TO: Mercedes-Benz Dealer Principals, General Managers, Sales Managers, Service Managers, Parts Managers	FROM: Gregory Gunther, Senior Manager, Vehicle Compliance and Analysis, Engineering Services
RE: Service Campaign Launch Notification Check Lens Hood of Multifunction Camera MY21-23 S-Class (223 platform)	DATE: December 20, 2024

Campaign No. 2024110005, December 2024

SUBJECT: **Model S-Class (223 platform)**
Model Year 2021 – 2023

Check Lens Hood of Multifunction Camera

Figure 1

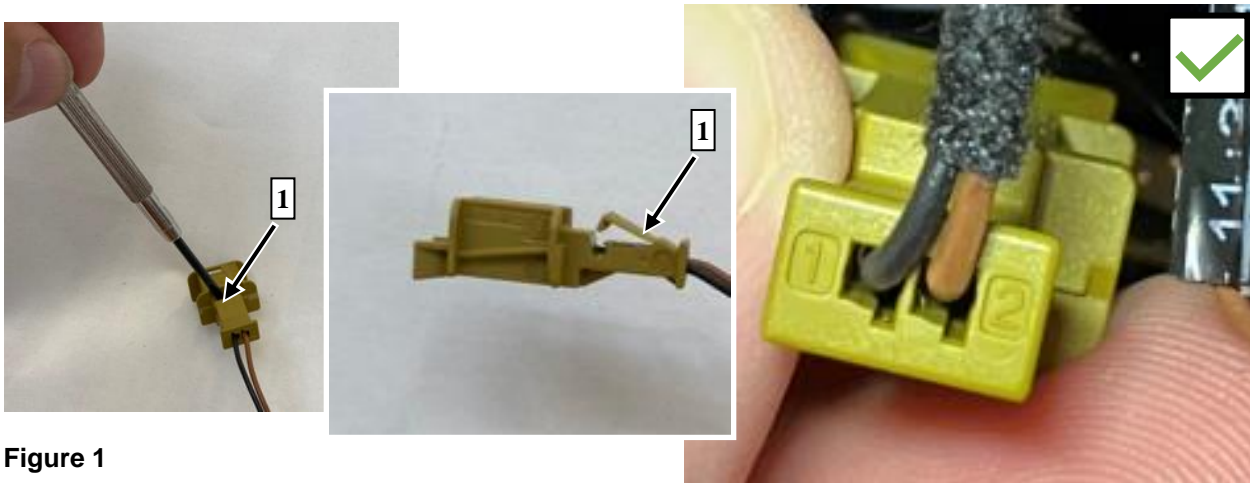
- i** Remove lens hoods from packaging, check the pin assignment in the connector housing, and correct it if necessary.
- i** Correct polarity: **Pin 1 = black (ground/negative); Pin 2 = brown (positive/+)** (Figure 1)

1. Carefully open the secondary lock of the connector (**Figure 1, 1**) and check/correct polarity.

i **Risk of damage:** Open the secondary lock so that the wiring harness pins can be backed out of the connector housing.

i Pull the pins out of the connector housing and insert them into the correct side of the connector if the polarity is incorrect. Ensure the pins are fully seated in the connector and close the secondary lock.

Figure 2

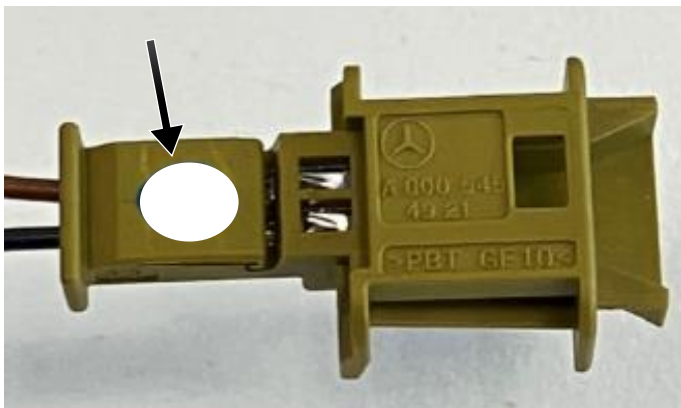
2. Mark connector housing with a white color dot (**Figure 2**).

- i** In the future, this mark will be used to identify a correctly reworked connector.

Figure 3

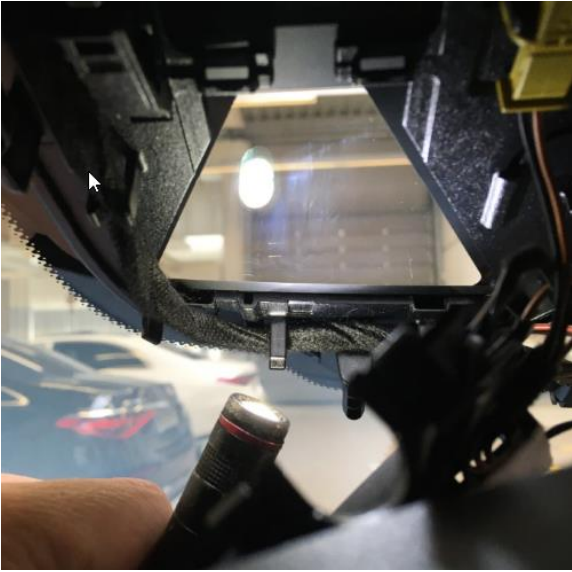
4. Clean windshield (**Figure 3**) in camera field of vision.

i Use clean paper towels during every operation.

i Ensure that there are no streaks or stripes after drying time.

i Check for streaks or stripes using a flashlight.

Figure 4

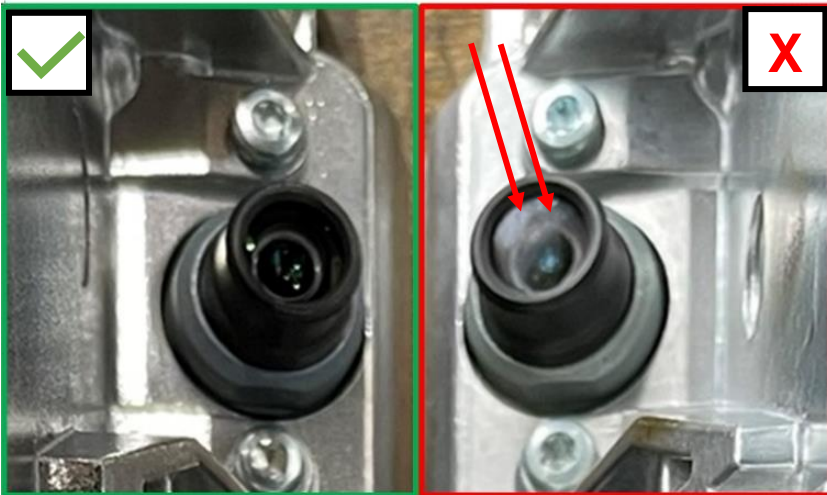
5. Check lenses of multifunction camera (**Figure 4**) for dirt build-up/soiling.

i If the lenses are dirty or soiled, the multifunction camera **must be replaced**.
